Technical Service Bulletin

Bulletin No.	R_01_2021
Date	February 2021

Carry-Bike Frame Ducato E-Bike Item No. 02094-27A / 02094A27A

9 mm

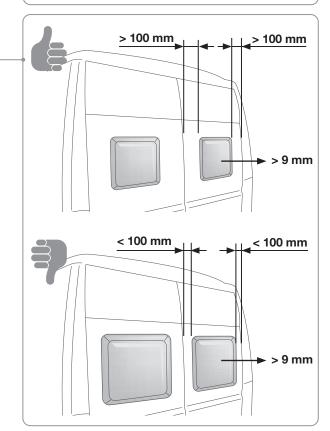
we inform you that the **Carry-Bike Frame Ducato** Item No. 02094-27A / 02094A27A Item No. 02094-32A / 02094A32A Item No. 02094-25A / 02094A25A **can be installed on:**

- 1. standard original vehicles (not modified)
- 2. camper vans with a rear window with a protrusion of less than 9 mm

3. camper vans with a rear window with a protrusion of more than 9 mm and distance from the edges of the tailgate greater than 100 mm

In case of Polyplastic or Remis windows, the Carry-Bike Frame Ducato can only be installed if the vehicle complies with the condition of point 3.
